RE: JMC Project 22021
26 Chestnut Ridge Road Improvements
26 Chestnut Ridge Road
Town of North Castle, New York

Response to comments included in a Kellard Sessions Memorandum to the Town of North Castle Planning Department, dated April 22, 2022.

SITE PLAN

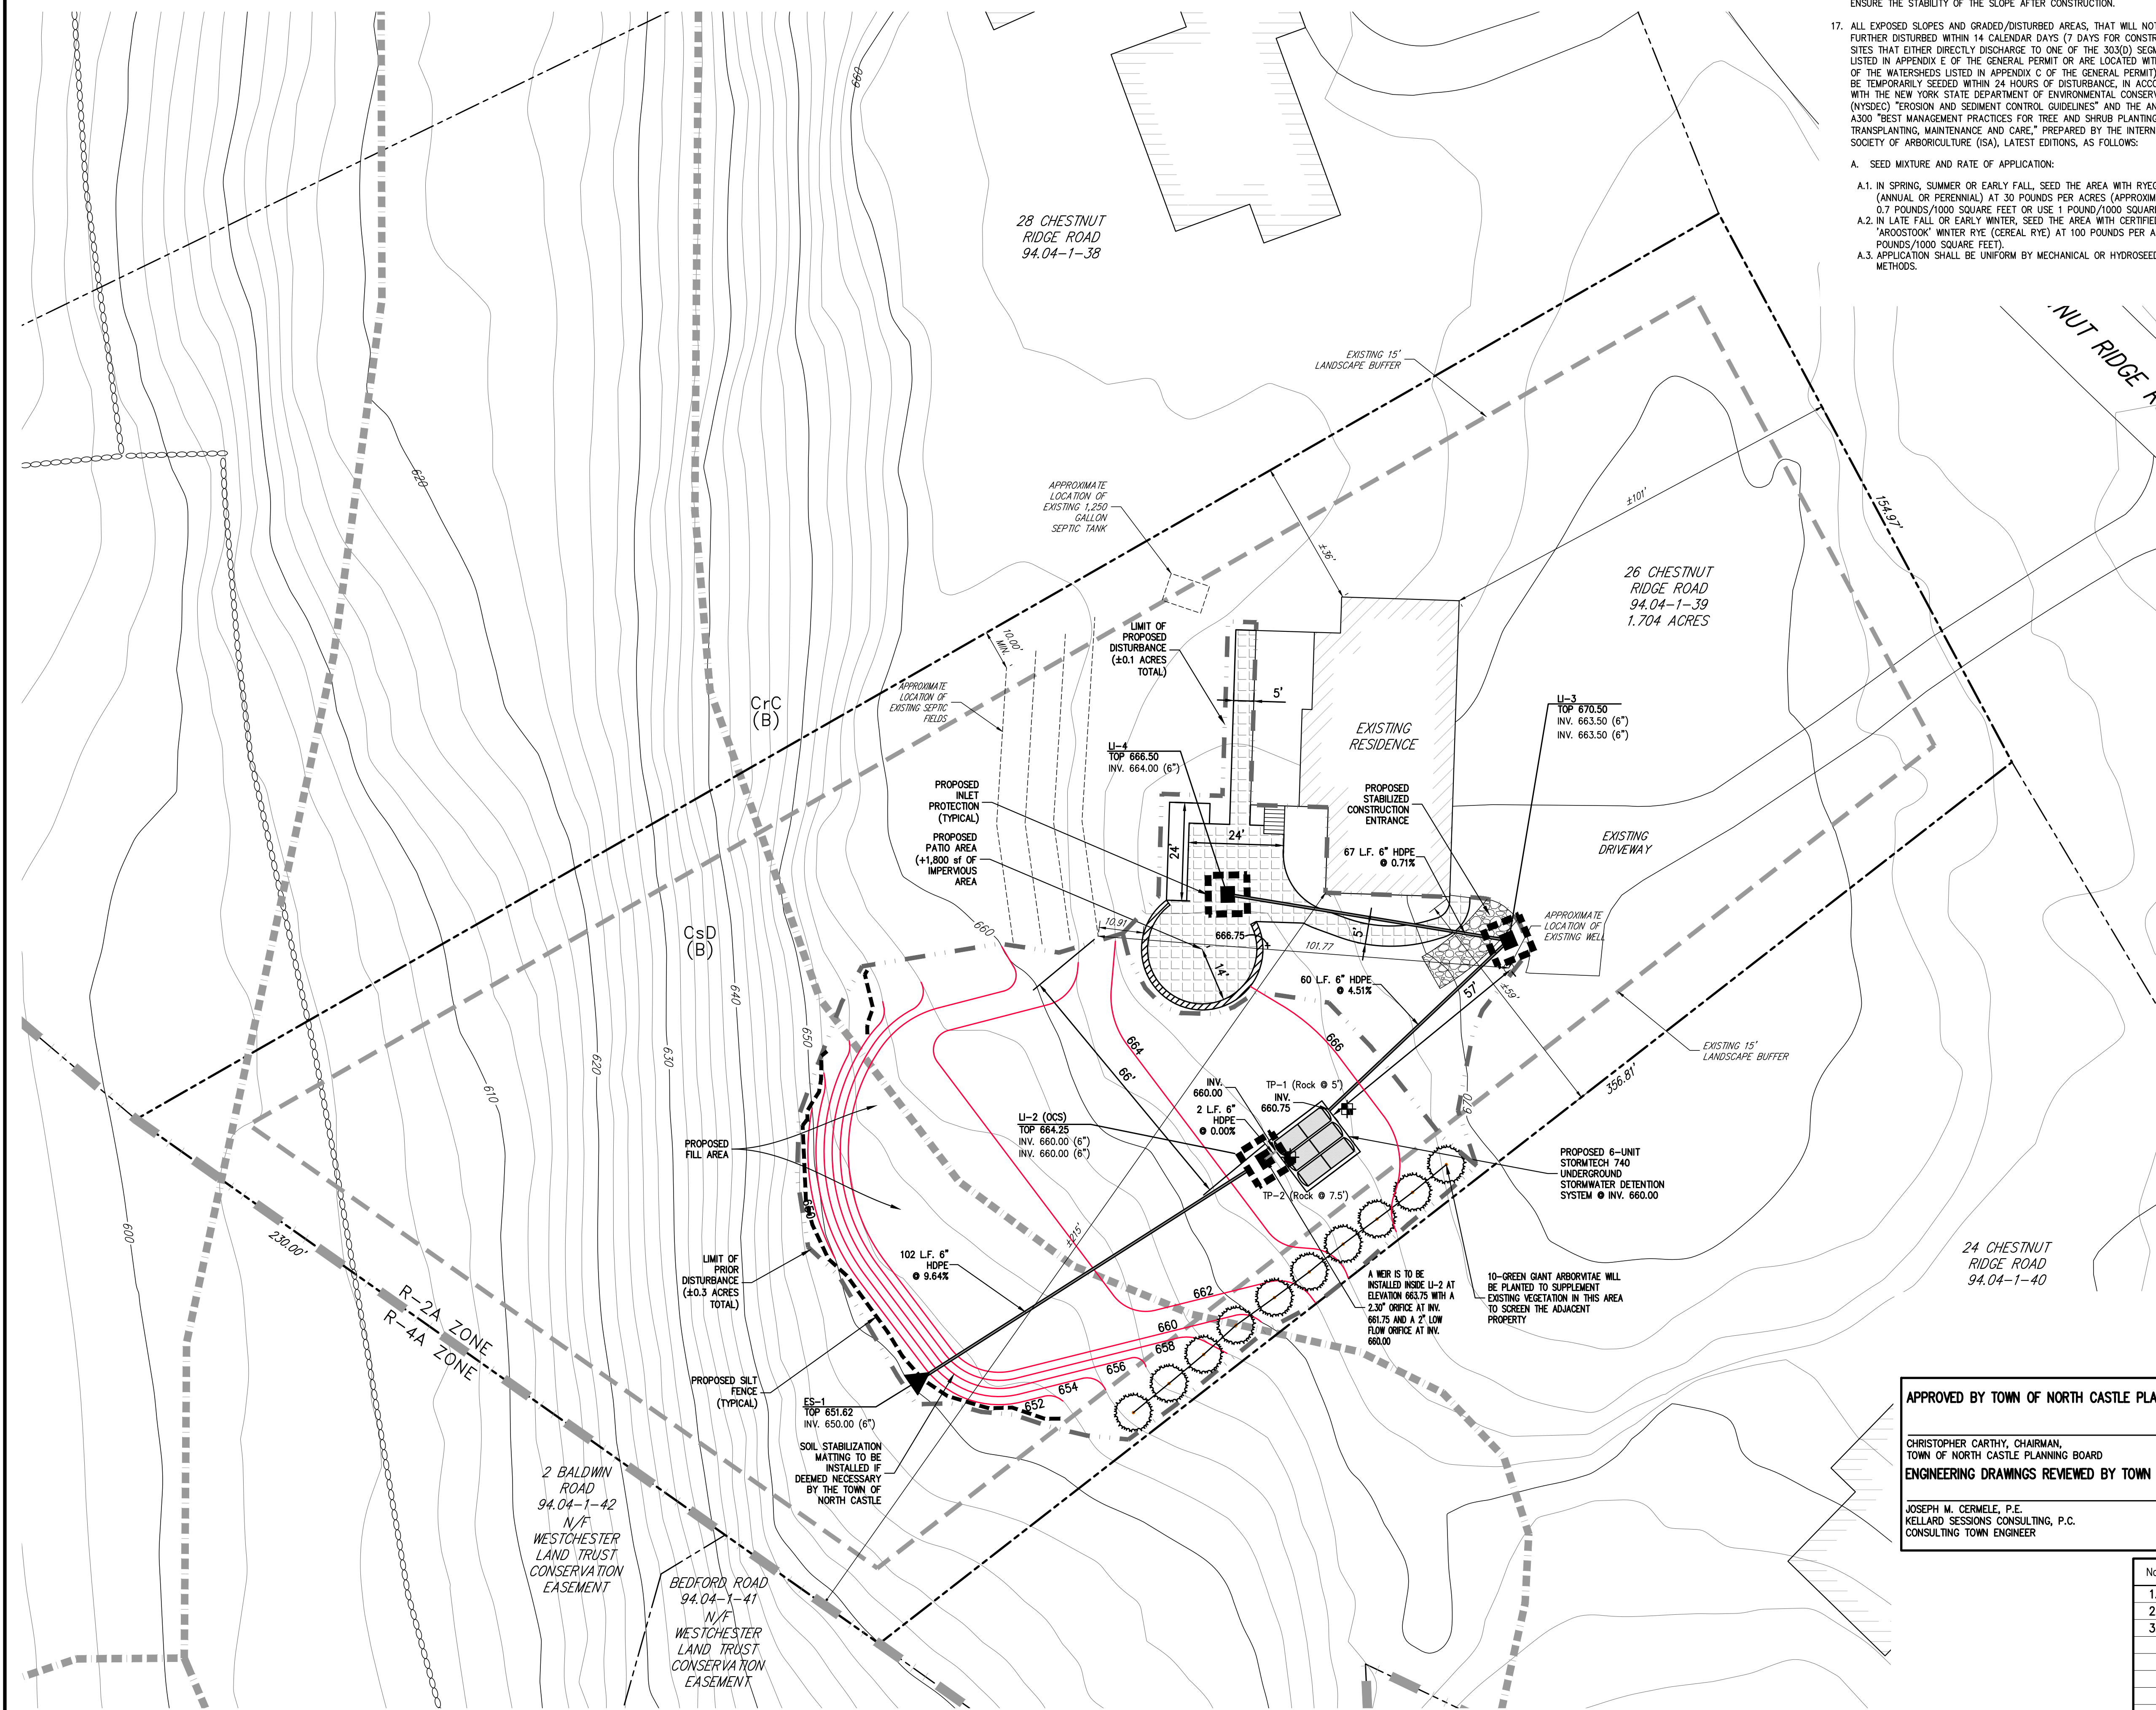
Please redirect the detention system outflow away from the proposed plantings along the neighboring property boundary. The preferred location would be below the proposed fill and embankment. Please provide a level spreader to dissipate the flows.

The Site Plan has been updated to show the new outlet location below the proposed fill and embankment instead of its previous location.

It is understood that the system is not an infiltration system, however, the applicant shall perform deep soil testing at the location of the detention system to verify soil conditions will permit the installation of the system.

Deep test pits were performed by JMC and witnessed by a representative of Kellard Sessions on April 26th, 2022. These test pit locations have been added to the Site Plans with depth of bedrock included in the labels of these test pits. The proposed stormwater system has been shifted slightly to align with test pit #2, to ensure it's constructability.

STORMTECH CHAMBERS SC-740 6

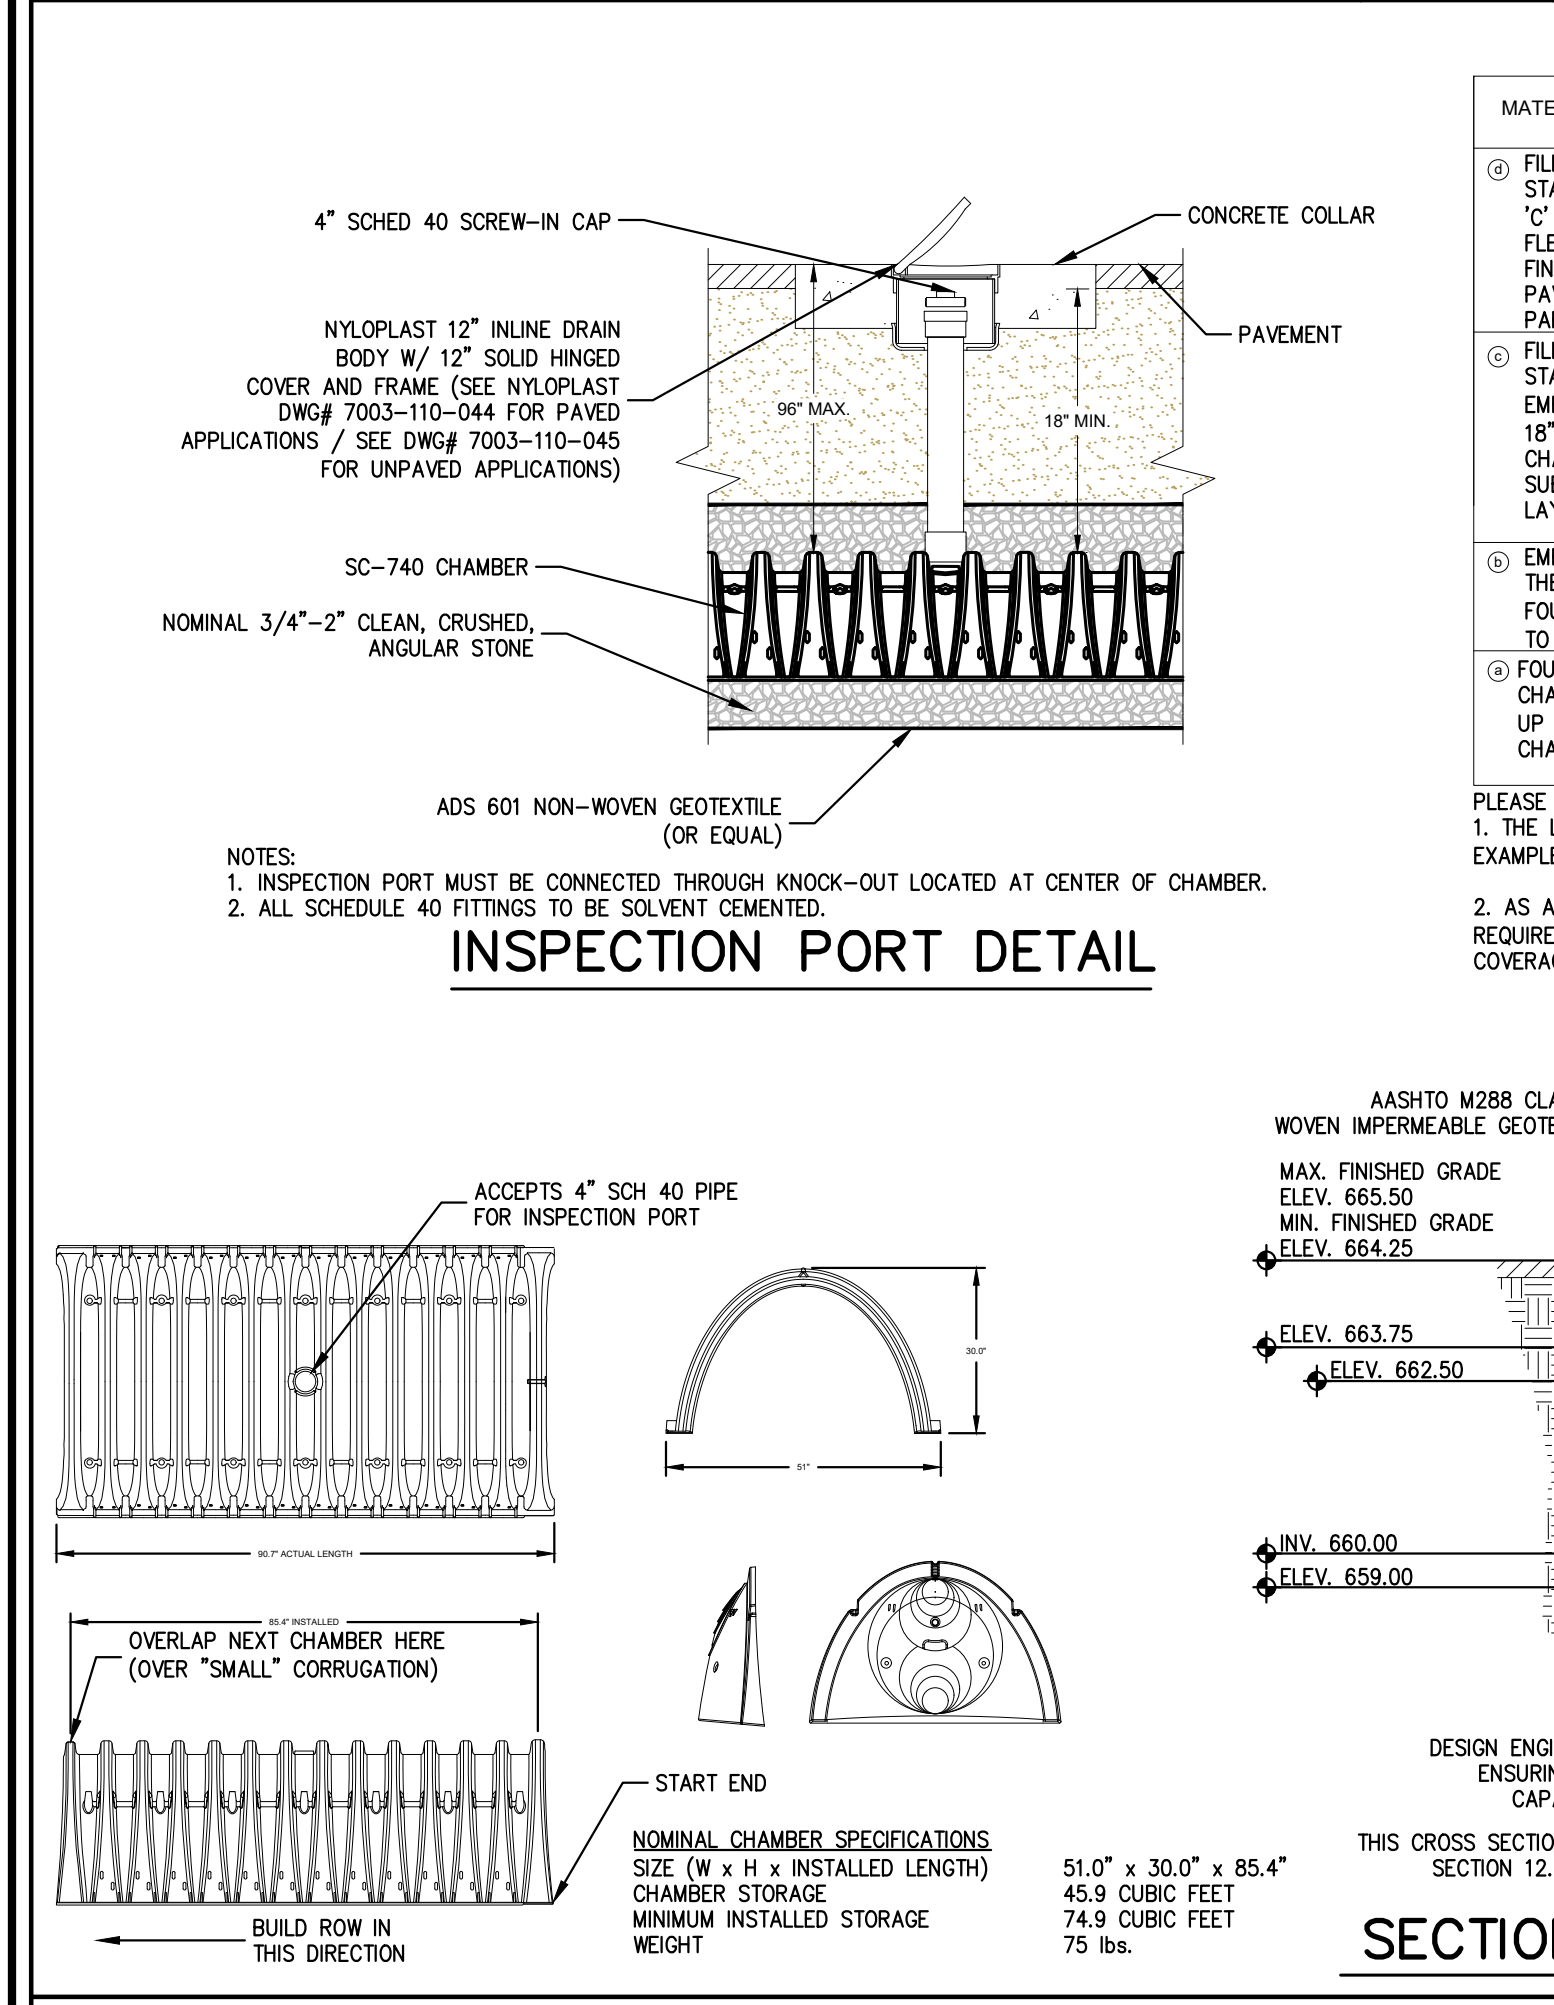
The applicant is proposing four (4) Stormtech 740 Units. The manufacturer's specifications indicate a total storage volume of 78.47 c.f. per unit with a 9" stone base, which would equate to 313.88 c.f. of total storage. A 6" stone base is proposed which would result in less storage volume. The design also includes an impermeable geotextile surrounding the units and gravel which extends to elevation 666.5. Stormwater calculations indicate a high water elevation of 667 during a 100-year event with 418 c.f. of storage. Approximately 100 c.f. or 33% more volume than the manufacturer indicates is provided. Please clarify.

The stormwater calculations were performed using a stone base of 12 inches and 15 inches of stone cover on top of the system. The detail has been updated to reflect this. It should be noted that the system was not designed to store the entirety of the 100-year storm event but to detain the runoff as it enters the system over a 24-hour period and release the runoff slowly as to reduce the peak flow from existing conditions to proposed conditions. In the stormwater program that was used for the calculations provided (Pond Pack), a value entered by the user is identified as the "invert of the system". The design engineer was assuming the "invert of the system" was referring to the invert of the actual chambers but what it was actually referring to was the bottom of the stone base. In the original design, the bottom of the stone was mistakenly set at 662.50. With 12 inches of stone base, a 30-inch-tall chamber and 12 inches of stone cover, the top of the system would be 667.00, just over the high-water level of 666.96. This has been updated in the Pond Pack model. The system has been relocated based on the soils testing and all inverts above have been updated accordingly.
